10.4 Other Features of Steam and Power Conversion

The information in this section of the reference ABWR DCD, including all subsections, tables, and figures is incorporated by reference with the following departures and supplements.

Figure 10.4-6 Feedwater System

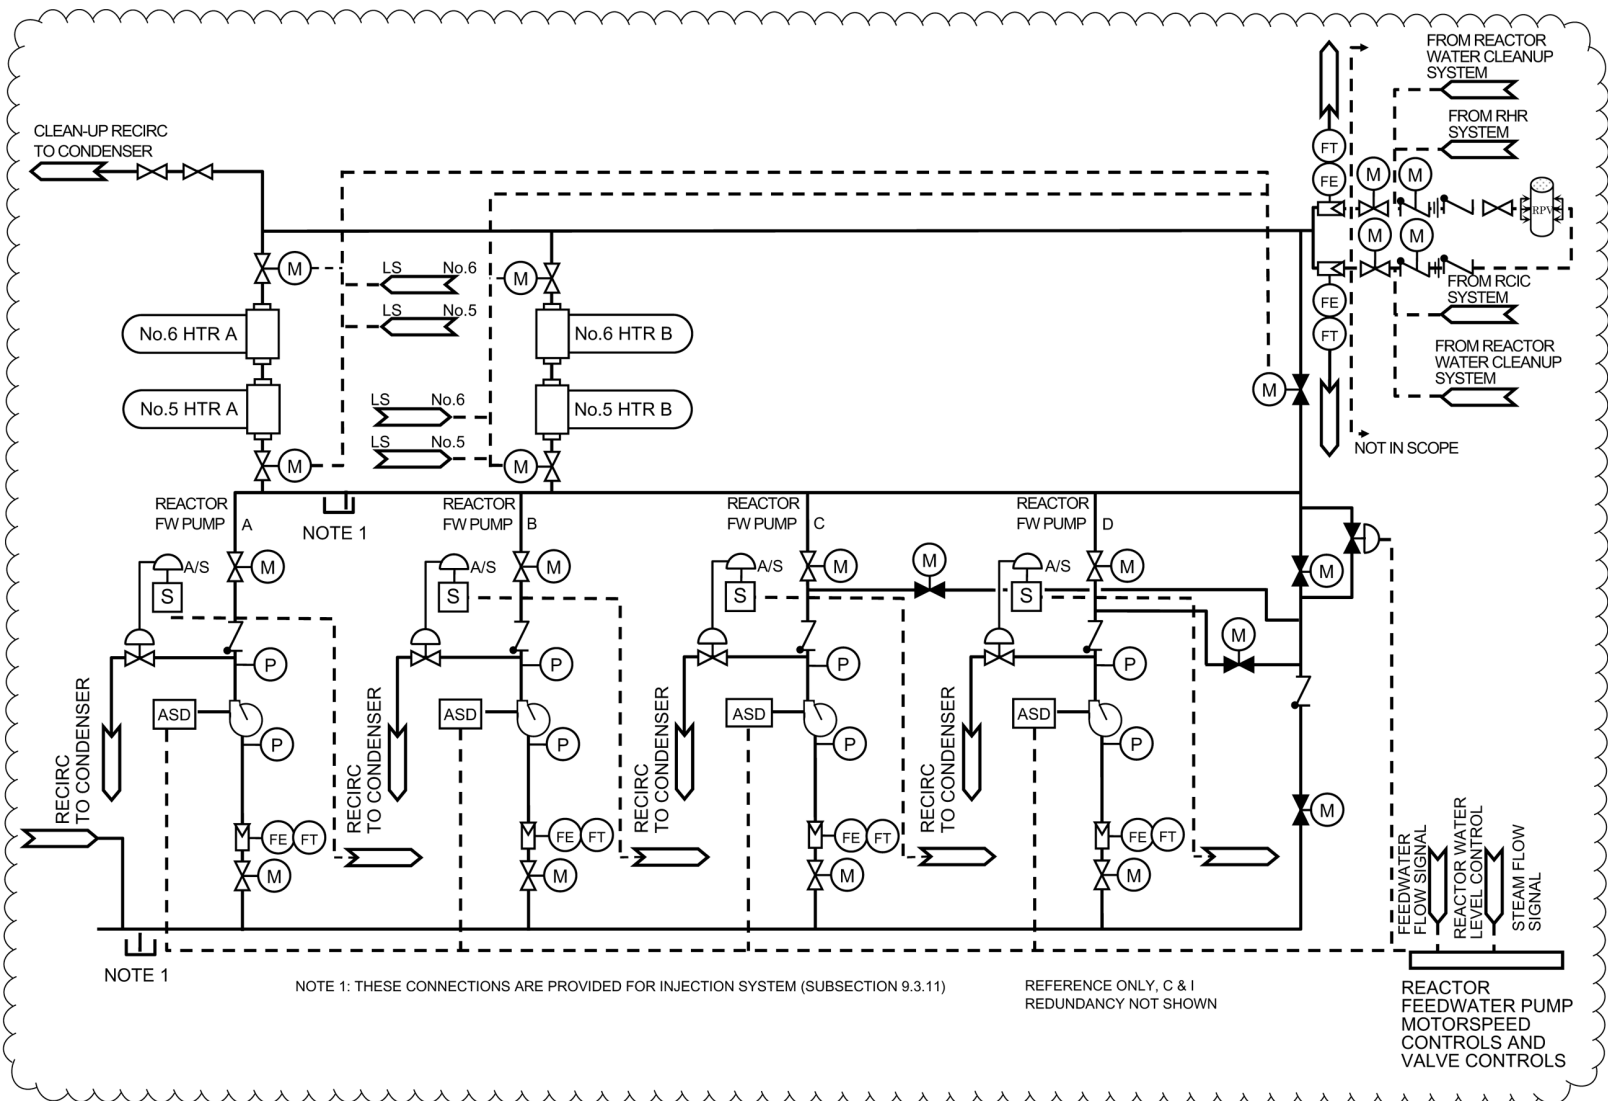
STD DEP 10.4-5 (Tables 10.4-4, 10.4-5 and 10.4-6, Figures 10.4-5, 10.4-6, 10.4-7, and 10.4-8)

The Condensate and Feedwater System (Figures 10.4-5 and 10.4-6) consists of the piping, valves, pumps, heat exchangers, controls and instrumentation, and the associated equipment and subsystems which supply the reactor with heated feedwater in a closed steam cycle utilizing regenerative feedwater heating. The system described in this subsection extends from the main condenser outlet to (but not including) the seismic interface restraint outside of containment. The remainder of the system, extending from the restraint to the reactor, is described in Chapter 5. Turbine cycle steam is utilized for a total of six stages of closed feedwater heating. The drains from each stage of the low-pressure feedwater heaters are cascaded through successively lower pressure feedwater heaters except the lowest and second lowest pressure feedwater heaters which drain to the low pressure heater drain tanks for each string. The drains from each low pressure heater drain tank flow into the external drain coolers of each lowest pressure feedwater heater and finally to the main condenser. The high pressure heater drains are pumped backward to the reactor feedwater pumps suction. The cycle extraction steam, drains and vents systems are illustrated in Figures 10.4-7 and 10.4-8.

Reactor Feedwater Pumps—~~Three~~ Four identical and independent ~~33–65%~~ 33% capacity reactor feedwater pumps (RFP) are provided. ~~The~~ Three pumps normally manually operate in parallel and discharge to the high-pressure feedwater heaters. The pumps take suction downstream of the last stage low-pressure feedwater heaters and discharge through the high-pressure feedwater heaters. Each pump is driven by an adjustable speed drive.

Isolation valves are provided which allow each reactor feed pump to be individually removed from service for maintenance, while the plant continues operation at full power on the ~~three~~ two remaining pumps.

Figure 10.4-9 Bypass Valve Control, Electro-Hydraulic Control Unit

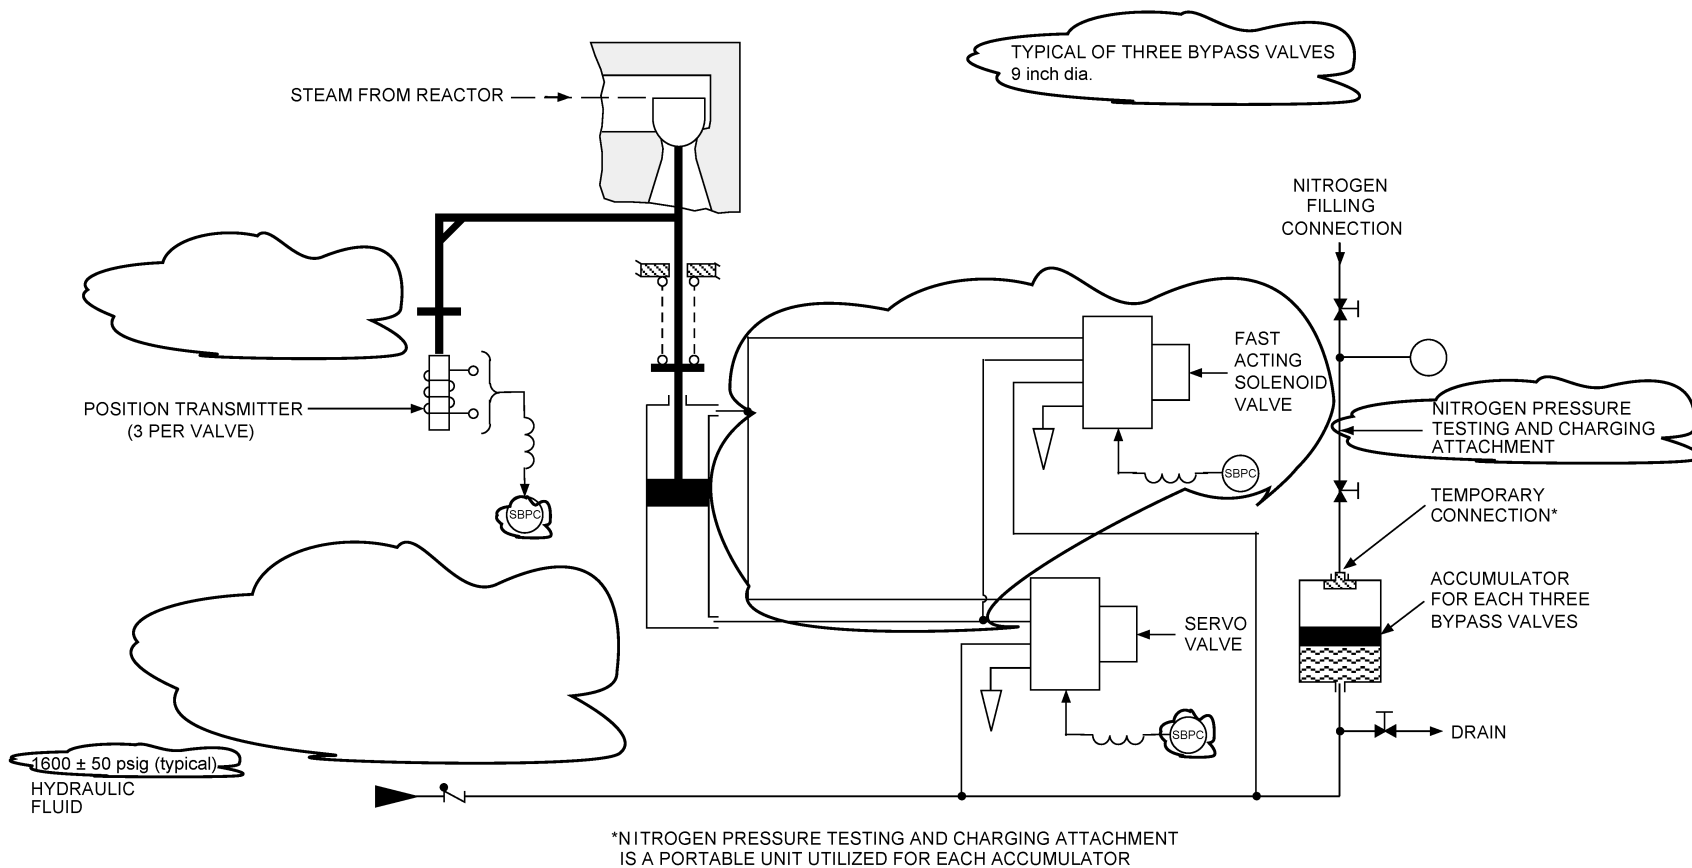
STD DEP 10.4-7 (Figure 10.4-9)
